SACRAMENTO CITY PLANNING COMMISSION 1231 "I" STREET, SUITE 200, SACRAMENTO, CA 95814

LOCATION: 4308 E Street

PROPOSAL: The applicant is requesting the necessary entitlements to construct a 640 square foot second residential unit

APPLC. NO. P91-113 MEETING DATE September 26, 1991 ITEM NO. 18

EXHIBIT B LOOK TO HOT WATER WEST ELEVATION COMPOSITION BHINGLES OVER 12 PLYND, SHEATHING. STORE CONTRACT 000930 ITEM NO 18

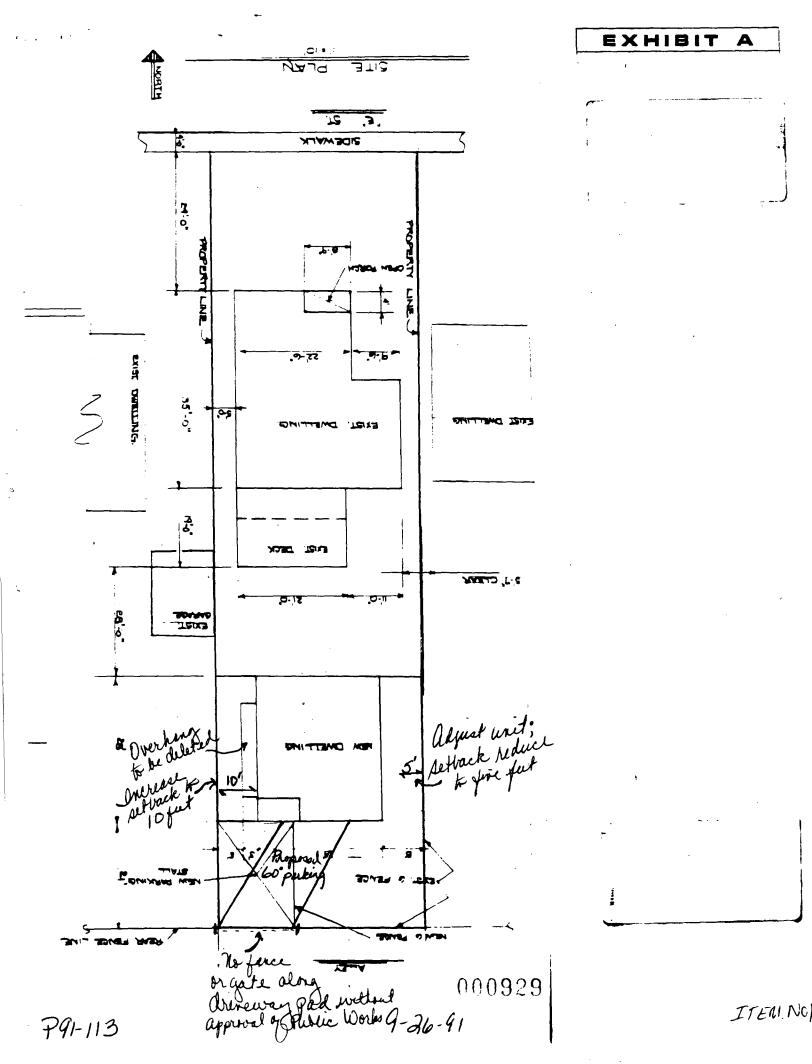
The Zoning Ordinance requires a minimum ten foot courtyard between buildings and property line to allow for adequate access, light and air. The applicant is requesting a variance from this regulation. Since the front unit is existing the applicant is unable to provide the required ten feet. Staff finds the five feet adequate to provide light and air to the main unit and recognizes that the residents of the second unit will access the rear unit from the alley rather than E Street. minimum four foot paved walkway should be provided along the west property line from the front of the lot to the rear unit for access to the rear unit, since quest that visit the residents in the rear unit will park on E Street and walk to the rear of the lot. The proposed second unit, which has the main entrance to the dwelling unit off the side (west) property line has a proposed five foot courtyard area. Staff recommends the unit be shifted to the east allowing for a five foot side setback on the east property line, relocating the water heater enclosure to the south or north elevation of the unit and deleting the

three foot overhang on the west elevation to provide the ten foot courtyard requirement for the second unit. (Exhibit A)

The unit will be constructed of wood siding and stucco with a composition shingle roof. The south elevation and a portion of the west elevation, where the main entrance will be located, will be wood siding with the north, east and west elevations being stucco. The applicant proposes to provide landscaping along the north elevation in order to minimize the visual impact of the second unit on the front unit. recommends a minimum of three foot high bushes to be planted in order to The main entrance will be a provide some relief from this elevation. recessed covered porch area, which is to remain unenclosed. foot overhang is proposed along the west property line. recommends deleting this overhang in order to comply with the ten foot courtyard requirement. The pitch of the roof should be similar to the existing house and the roofing material should be a 25 year laminated dimensional shingle.

- 6. The second unit's roof pitch shall match the existing unit. Elevations reflecting the roof pitch of both the existing unit and proposed unit shall be reviewed and approved by the Planning Director prior to issuance of building permit.

1. The second residential unit shall be constructed with a ten foot courtyard requirement along the west property line.
